**Re:** 45 Bishop Street, Draft Plan of Subdivision  
Township of Selwyn  
3<sup>rd</sup> Submission – Plan of Subdivision, Official Plan Amendment and Zoning By-law Amendment

**File #:** Township of Selwyn C-04-21  
County of Peterborough 15T-21002 and 15OP-21007

3<sup>rd</sup> Submission Comment Response Matrix as of March 4, 2025

SITE PLAN FILE No.:  
22088\_SERVICING

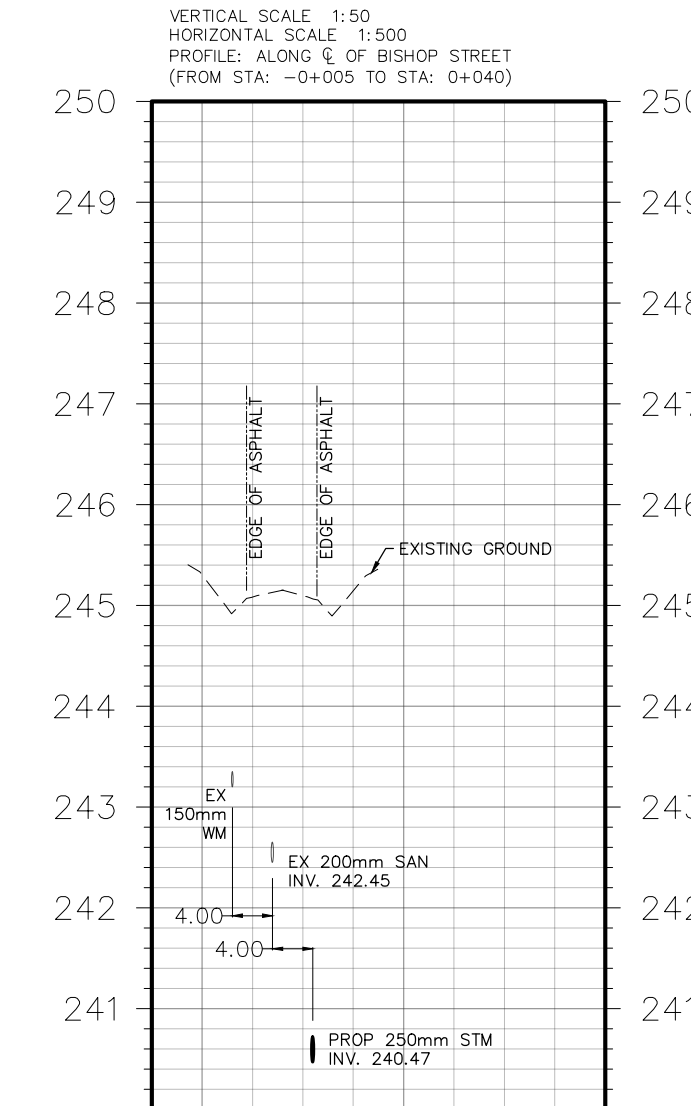
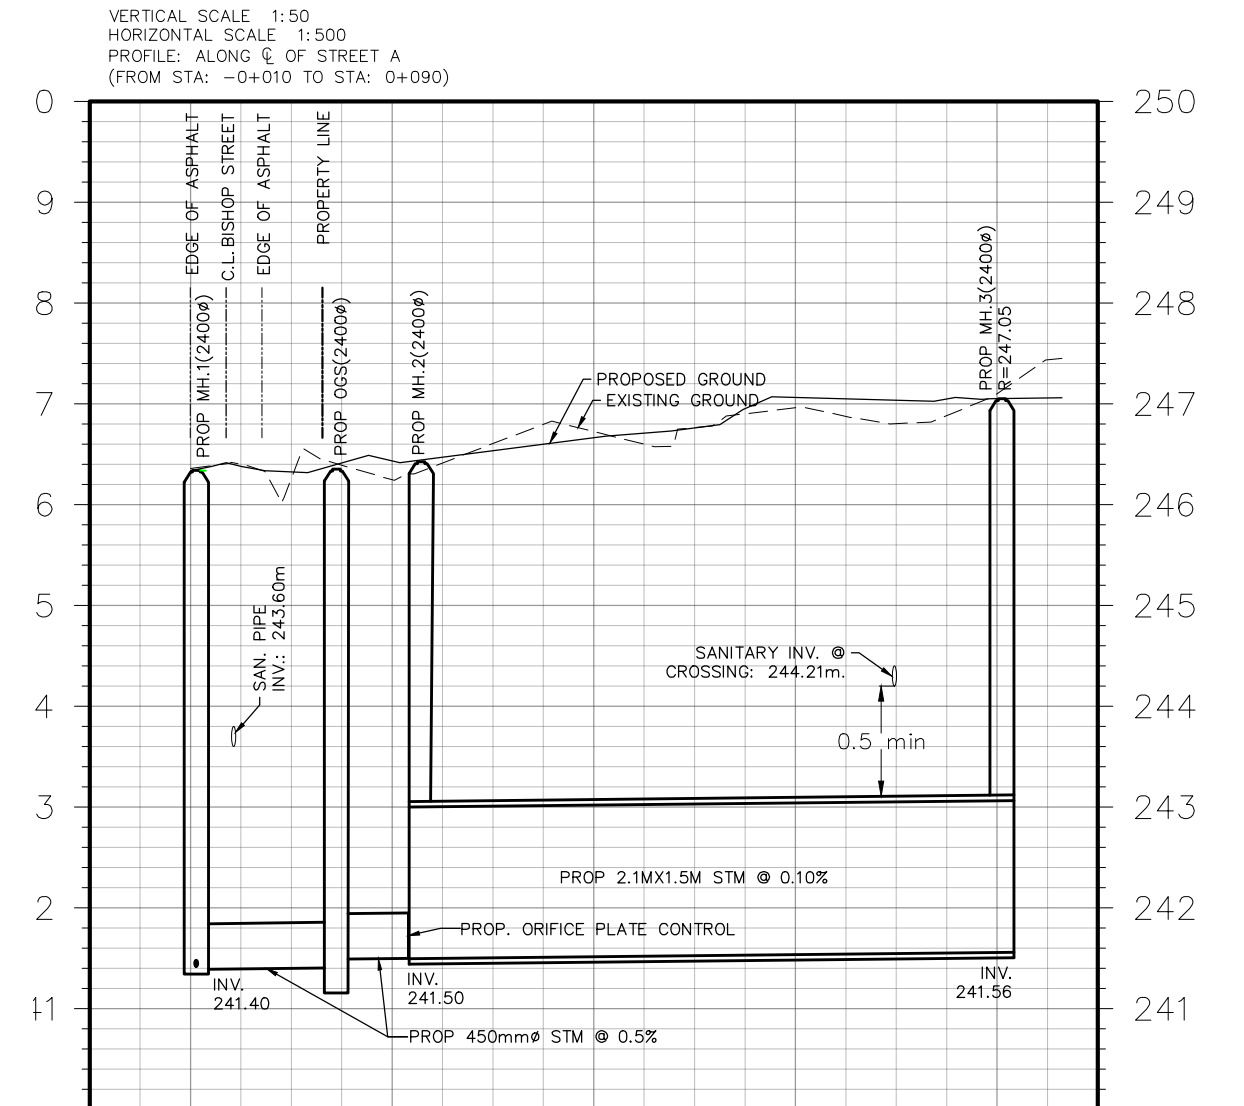
| No.  | 1 <sup>st</sup> Submission Comment (June 17, 2021)                                                                                                                                                                                                                                                                                                       | Response from Applicant                                                                                                                                                                                                                                                                                                                                                                                                                                                                                          | 2 <sup>nd</sup> Submission Comment (August 2, 2024)                                                                                                                                                                                                                                                                                                                                                   | Accepted | Response from Applicant                                                                                                                                                                                                                                                                                                                                                                                                                                                                                                                                                                |
|------|----------------------------------------------------------------------------------------------------------------------------------------------------------------------------------------------------------------------------------------------------------------------------------------------------------------------------------------------------------|------------------------------------------------------------------------------------------------------------------------------------------------------------------------------------------------------------------------------------------------------------------------------------------------------------------------------------------------------------------------------------------------------------------------------------------------------------------------------------------------------------------|-------------------------------------------------------------------------------------------------------------------------------------------------------------------------------------------------------------------------------------------------------------------------------------------------------------------------------------------------------------------------------------------------------|----------|----------------------------------------------------------------------------------------------------------------------------------------------------------------------------------------------------------------------------------------------------------------------------------------------------------------------------------------------------------------------------------------------------------------------------------------------------------------------------------------------------------------------------------------------------------------------------------------|
| 5.1  | New Comment                                                                                                                                                                                                                                                                                                                                              |                                                                                                                                                                                                                                                                                                                                                                                                                                                                                                                  | Confirm the location of the existing services on Bishop Street and demonstrate that the proposed storm sewer alignment can be accommodated meeting the required offsets from the watermain and sanitary sewer system.                                                                                                                                                                                 | N        | During our meeting on February 4, 2025 the Township and their peer reviewer DM Wills agreed that this comment can be addressed by the submission of a preliminary cross section and plan view demonstrating the location of existing services in relation to the proposed storm sewer on Bishop Street. Accordingly, a Servicing Figure and Cross Section is included in this submission. The preliminary location of the Storm Sewer is proposed on the north side of Bishop Street to isolate disturbance and allow for the flow of traffic.                                         |

| No. | 1 <sup>st</sup> Submission Comment (June 17, 2021)                                 | Response from Applicant               | 2 <sup>nd</sup> Submission Comment (August 2, 2024)                                                                                                                                                                                                                                                                                                                                                                                                                                                                                                                               | Accepted | Response from Applicant                                                                                                                                                                                                                                                                                                                                                                                                                                                                                                                                                                                                                                                                                                                                                                                                                                                                                                                                                                                                                                                                                                                                                                                                                                                                                                                                                                |
|-----|------------------------------------------------------------------------------------|---------------------------------------|-----------------------------------------------------------------------------------------------------------------------------------------------------------------------------------------------------------------------------------------------------------------------------------------------------------------------------------------------------------------------------------------------------------------------------------------------------------------------------------------------------------------------------------------------------------------------------------|----------|----------------------------------------------------------------------------------------------------------------------------------------------------------------------------------------------------------------------------------------------------------------------------------------------------------------------------------------------------------------------------------------------------------------------------------------------------------------------------------------------------------------------------------------------------------------------------------------------------------------------------------------------------------------------------------------------------------------------------------------------------------------------------------------------------------------------------------------------------------------------------------------------------------------------------------------------------------------------------------------------------------------------------------------------------------------------------------------------------------------------------------------------------------------------------------------------------------------------------------------------------------------------------------------------------------------------------------------------------------------------------------------|
| 5.2 | New Comment                                                                        |                                       | Bishop Street is not planned for urbanization in the foreseeable future; therefore, the proposed storm sewer will essentially only service a single development. As such, please review the storm sewer alignment and existing ditch inverts on both sides of Bishop Street to minimize the length of the sewer and area of disturbance within the existing roadway. If significant disturbances to Bishop Street cannot be avoided, the Township may require urbanization of the south side of the roadway with curb, gutter and catchbasins to service the existing residences. | N        | <p>As discussed during our meeting on February 4, 2025, the disturbance associated with the proposed storm sewer on Bishop St. would be isolated to a single trench. The daylight location of the sewer to the ditch is demonstrated adequately on a functional level. The final location of the storm sewer ditch outlet will be addressed at the detailed design stage, as a Condition of Draft Plan Approval.</p> <p>At the detailed design stage, as a Condition of Draft Plan Approval, a topo survey of the entirety of the Bishop St. ditches can be completed in support of a capacity analysis of the same. Based on the analysis, ditch improvements (shaping) can be implemented if required, to improve stormwater conveyance, reduce stormwater storage requirements (i.e. superpipe) and minimize municipal infrastructure. As stated during the same meeting, the urbanization of Bishop St. is unnecessary and cost prohibitive to this small development. Accordingly, the Owner/Developer/Applicant requests that urbanization of Bishop St. be dismissed in consideration of the greater good of providing housing in the current housing crisis climate. In support of the dismissal of the urbanization of Bishop St. the Township requested a preliminary cost estimate for the urbanization of Bishop St. A cost estimate is included with this submission.</p> |

As noted in the response to the Township's comment 5.2 in the attached Comment Response Matrix, the storm sewer that is proposed to be constructed on Bishop Street (to service the proposed

development) will only be 250 mm in diameter. The construction of the storm sewer would be isolated to a single trench parallel to the north edge of asphalt, along Bishop Street. The length of the proposed storm sewer is estimated to be 170 m and outlet to the south ditch of Bishop Street, immediately west of 29 Bishop Street. If desired by the Township at the detailed design stage and as a Condition of Draft Plan Approval, a topo survey of the Bishop Street ditches can be completed in support of a capacity analysis of the same. Based on the analysis, ditch improvements (shaping) can be implemented if required, to improve stormwater conveyance, reduce stormwater storage requirements within the proposed development (i.e. superpipe) and minimize municipal infrastructure. This solution is current and second best suited for the proposed development and will minimize disturbance along Bishop Street.
